**ADDENDUM NUMBER 1 ON INVITATION TO BID ITB18KO-131**

**TITLE:** Building 700 Renovation – Phase 2

CONFORMANCE  
DOCUMENTS

**E101**

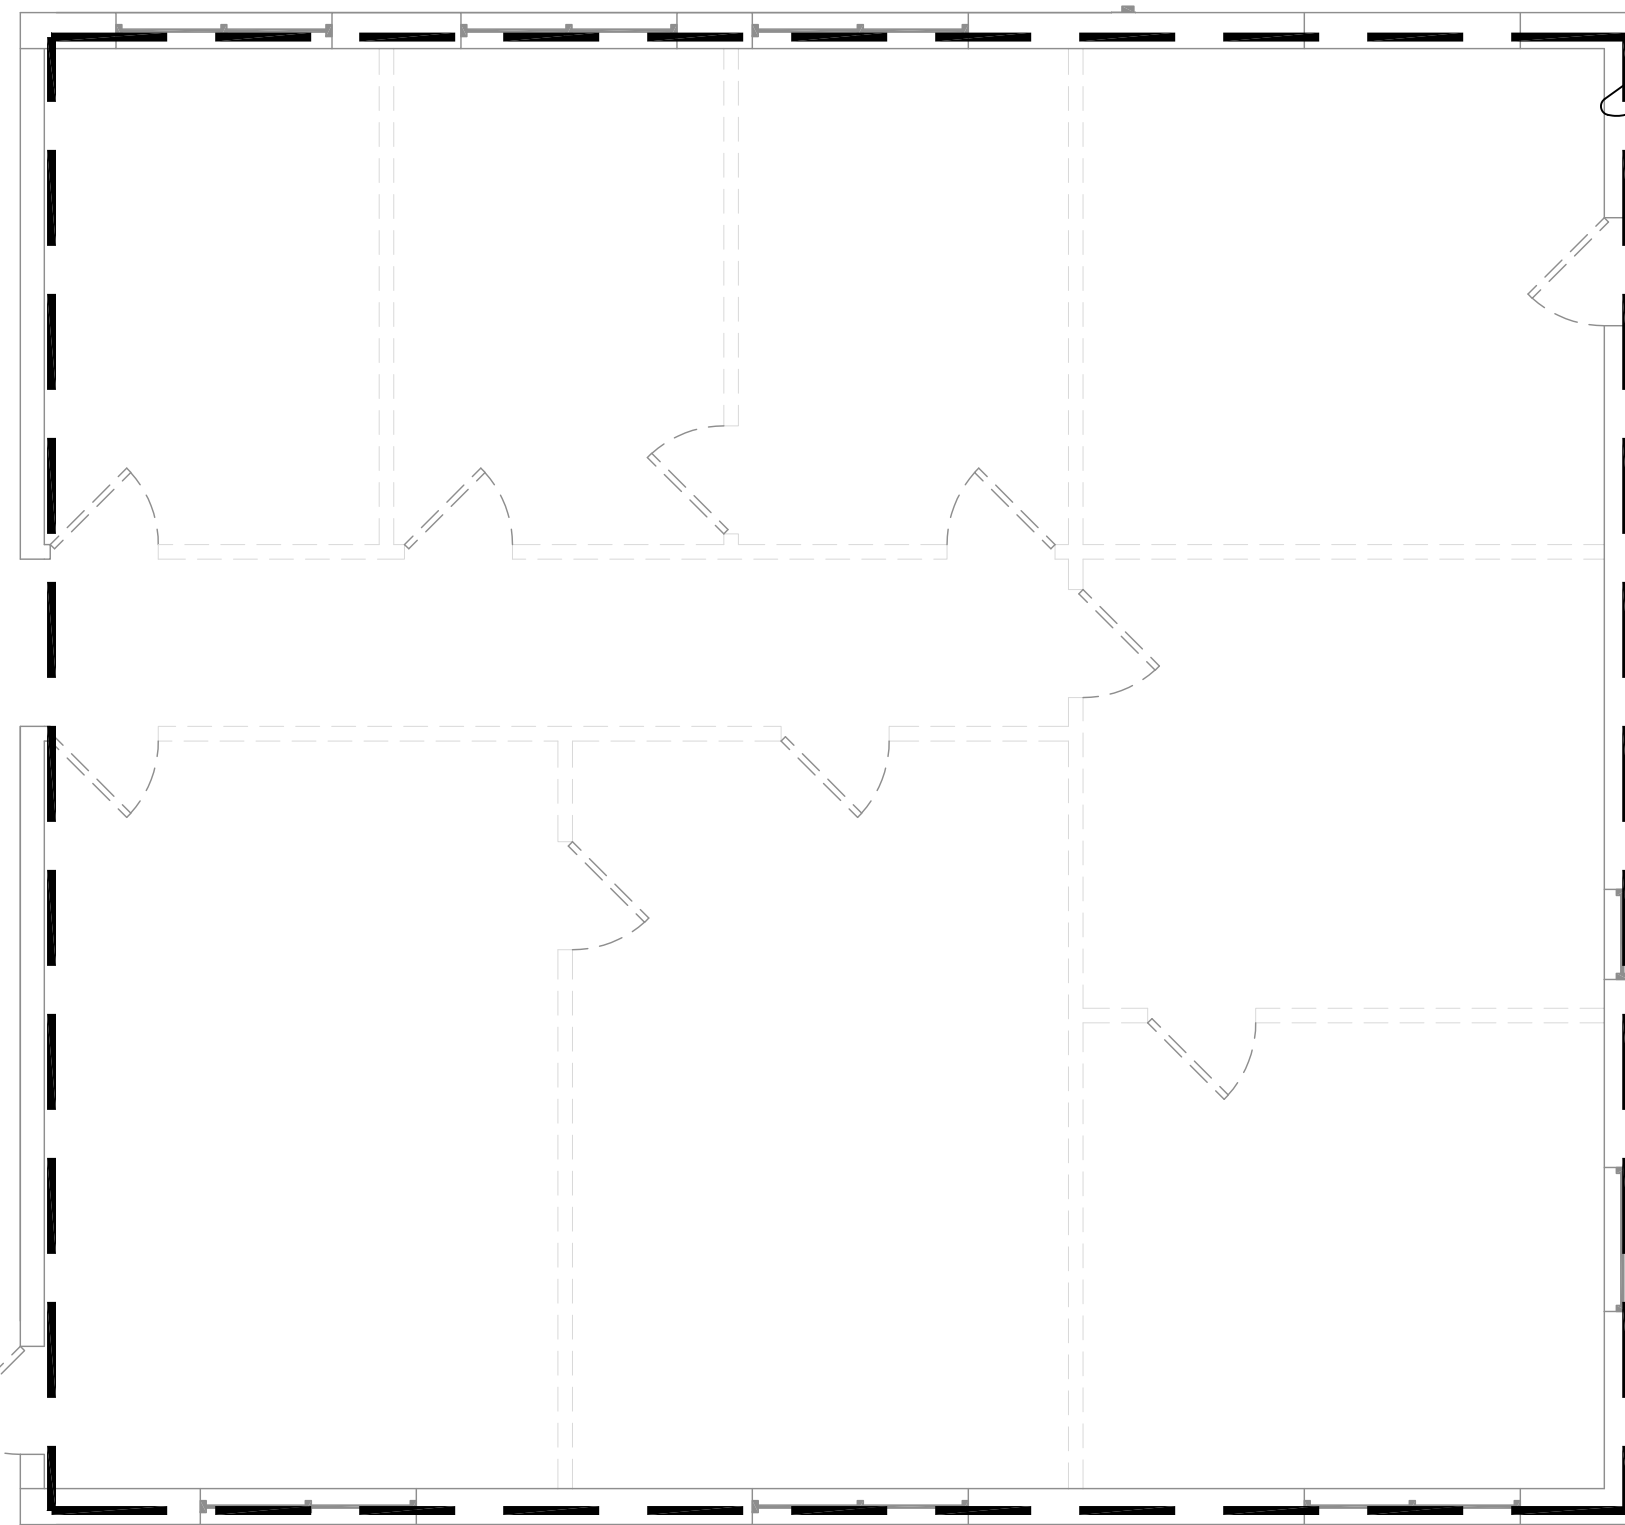
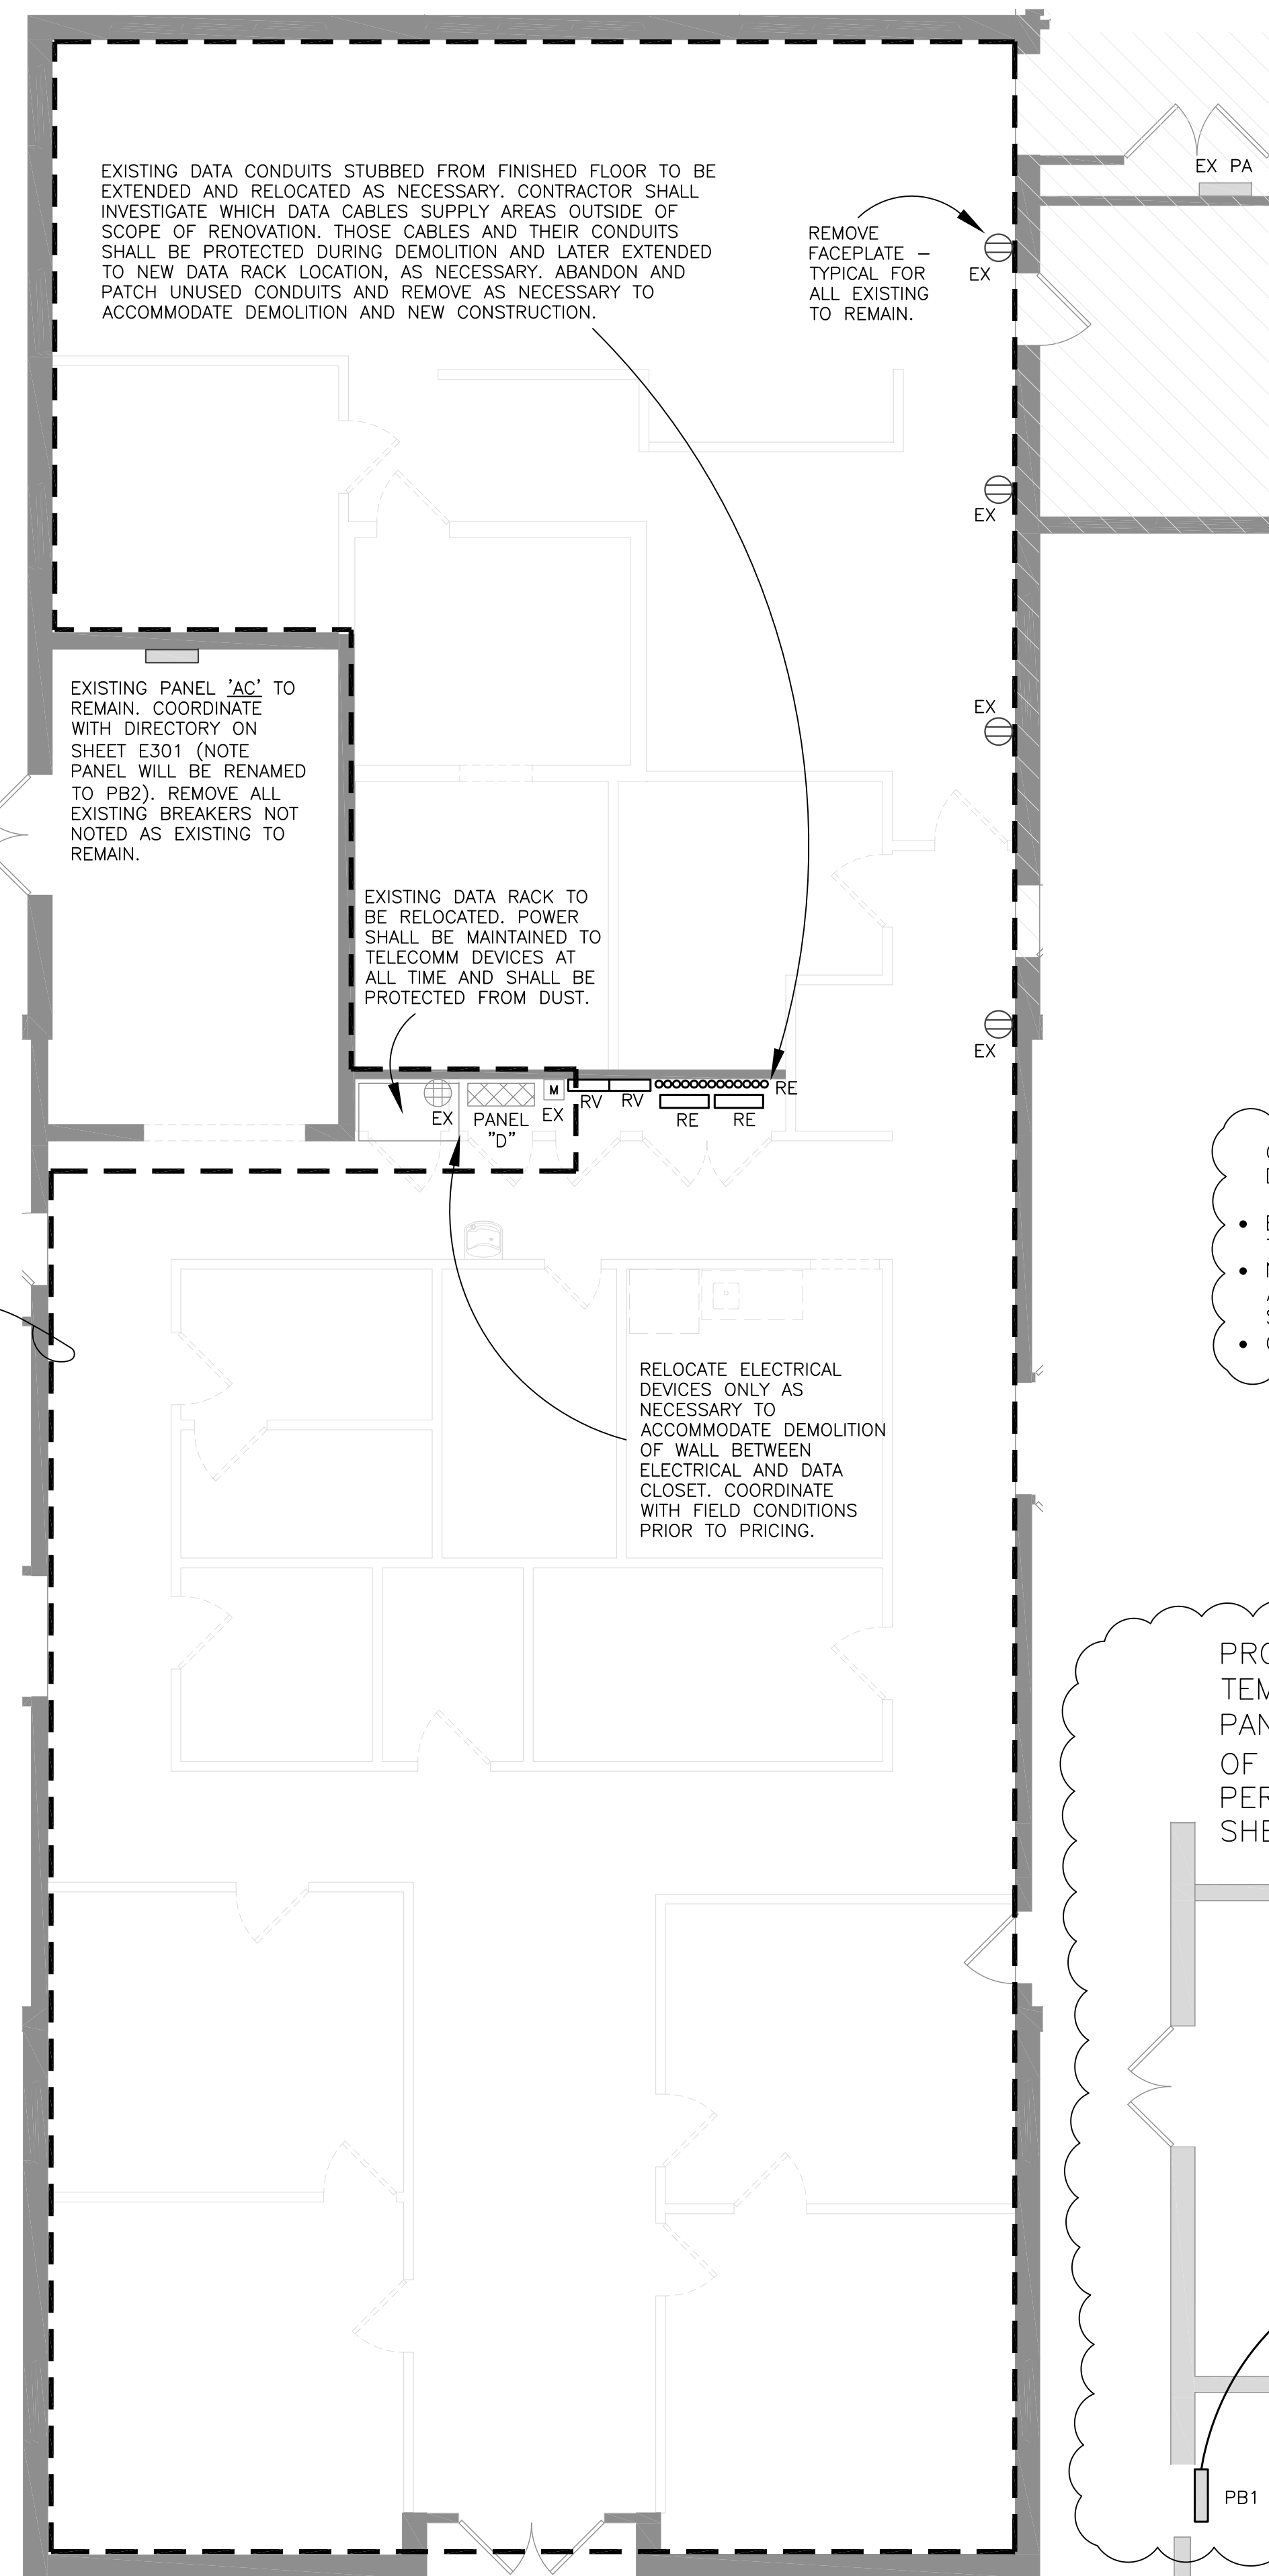
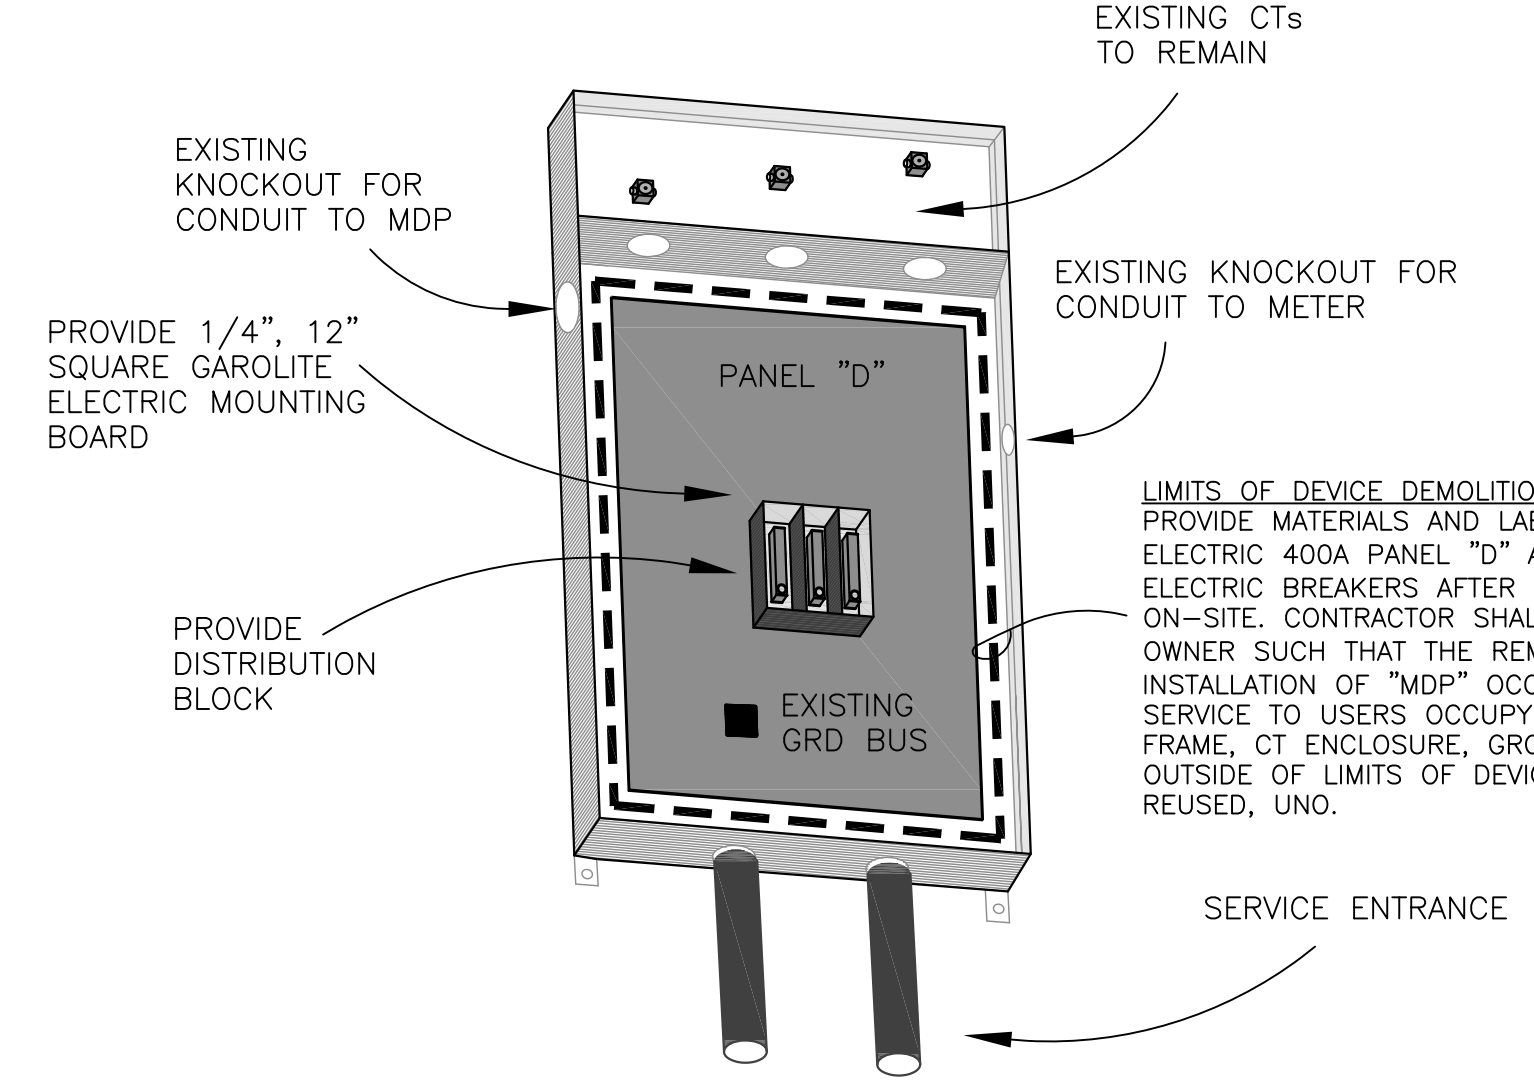
- EAST & WEST WING SECTIONS OF BUILDING ADDED TO DEMOLITION SCOPE.
- NOTES PERTAINING TO SCHEDULING PRIORITIES ADDED. CONTRACTOR SHALL COORDINATE EXACT SCHEDULING WITH OWNER PRIOR TO PRICING.
- CT ENCLOSURE/PULL BOX DETAIL ADDED.
